ZHL-2+ PCN Report

AN-60-069

ORIGINAL PART: ZHL-2

REPLACEMENT PART: ZHL-2+

CASE STYLE

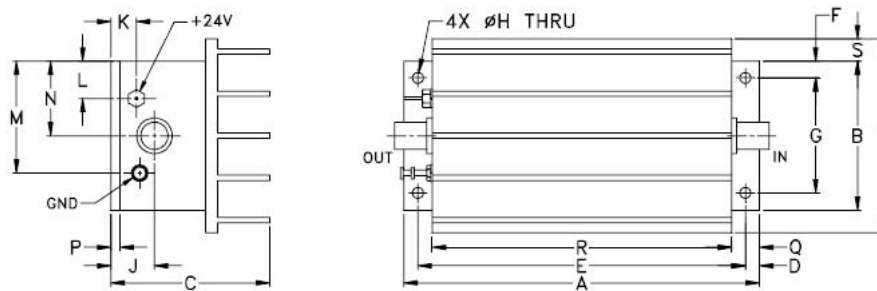
CASE STYLE: T34, No change

COMPARISON PERFORMANCE CURVES^a: T_{AMB}=25°C

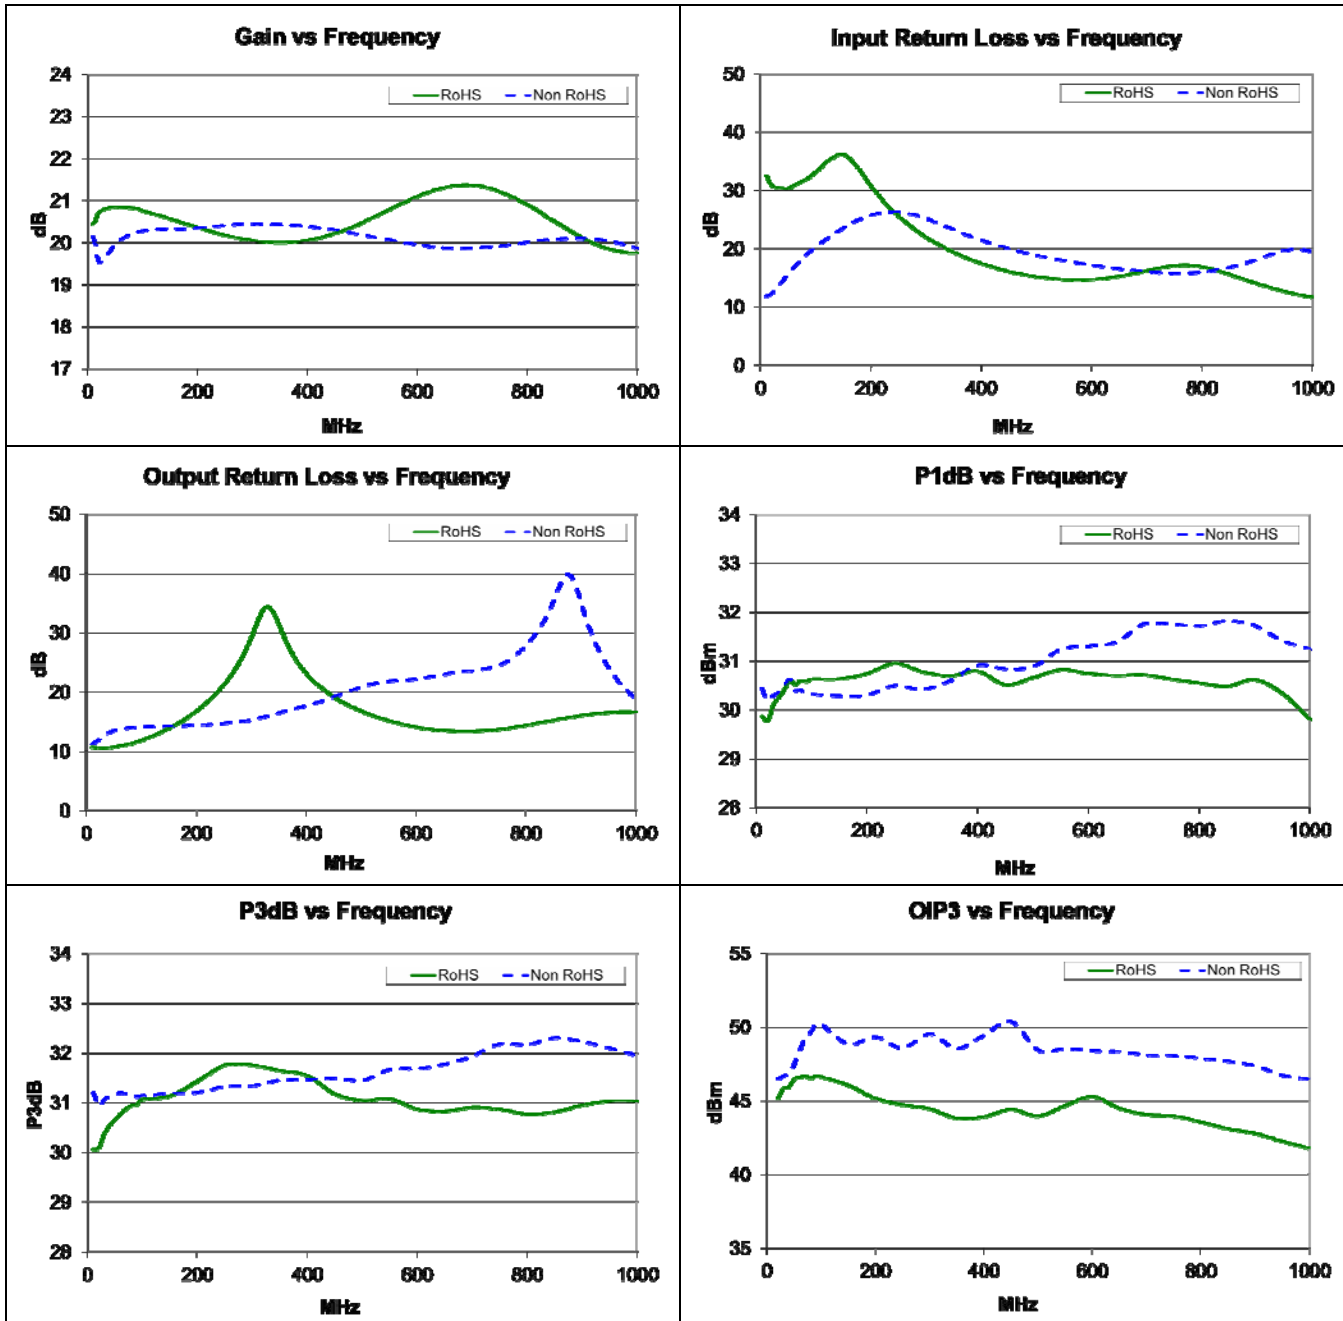
- 1) No change in FIT and FORM
- 2) Functional changes as follows:
